AGENDA for a meeting of the DEVELOPMENT CONTROL COMMITTEE in the Council Chamber, County Hall, Hertford on WEDNESDAY, 20 DECEMBER 2017 at 10.00AM.

- 1. APPLICATION FOR PROPOSED DEMOLITION OF BUILDINGS AND STRUCTURES ASSOCIATED WITH EXISTING RAIL AGGREGATES USE AND CONSTRUCTION AND OPERATION OF AN ENERGY RECOVERY FACILITY FOR THE TREATMENT OF MUNICIPAL, COMMERCIAL AND INDUSTRIAL WASTES; IMPORTATION, STORAGE AND TRANSFER OF LOCAL AUTHORITY COLLECTED HEALTHCARE WASTE TOGETHER WITH ANCILLARY INFRASTRUCTURE INCLUDING ADMINISTRATION/VISITOR CENTRE; INCINERATOR BOTTOM ASH STORAGE SHED; GRID CONNECTION COMPOUND; CAR, HGV, BUS AND VISITOR PARKING AREAS; RAIL SIDINGS IMPROVEMENTS; WEIGHBRIDGES AND WEIGHBRIDGE OFFICE; 2 PORTACABIN OFFICES; SPRINKLER TANK AND PUMP ROOM; DRAINAGE CONNECTION TO RIVER LEE; SECURITY FENCING; LANDSCAPING AND HIGHWAY IMPROVEMENTS TO RATTYS LANE AT LAND AT 2, RATTY'S LANE, HODDESDON, EN11 0RF.**

- 1.1 To consider planning application reference 7/0067-17 for the proposed demolition of buildings and structures associated with existing rail aggregates use and construction and operation of an energy recovery facility for the treatment of municipal, commercial and indus

Elevation C - North Western Facade
1:250

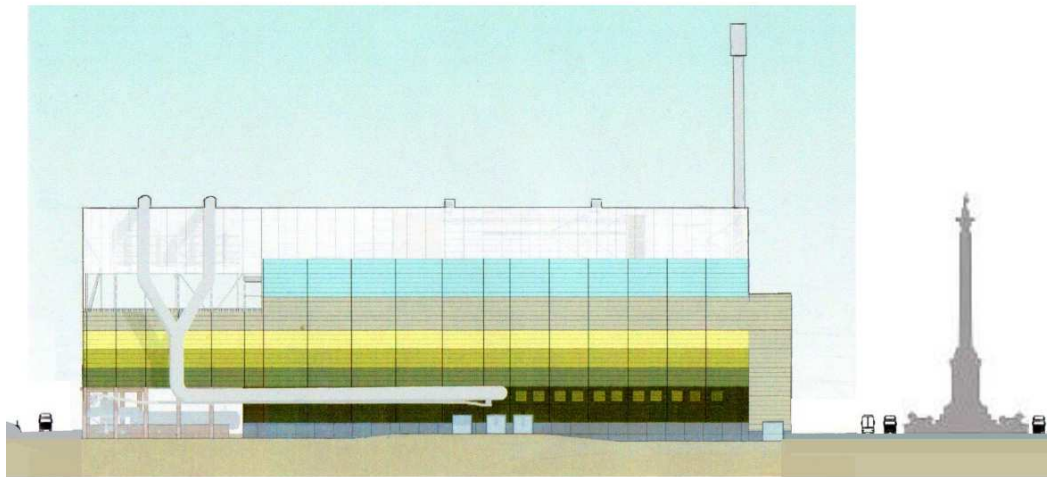
VIEWED FROM THE NORTH WEST (i.e. across the railway line)
AND
COMPARED (at the same scale) WITH NELSON'S COLUMN
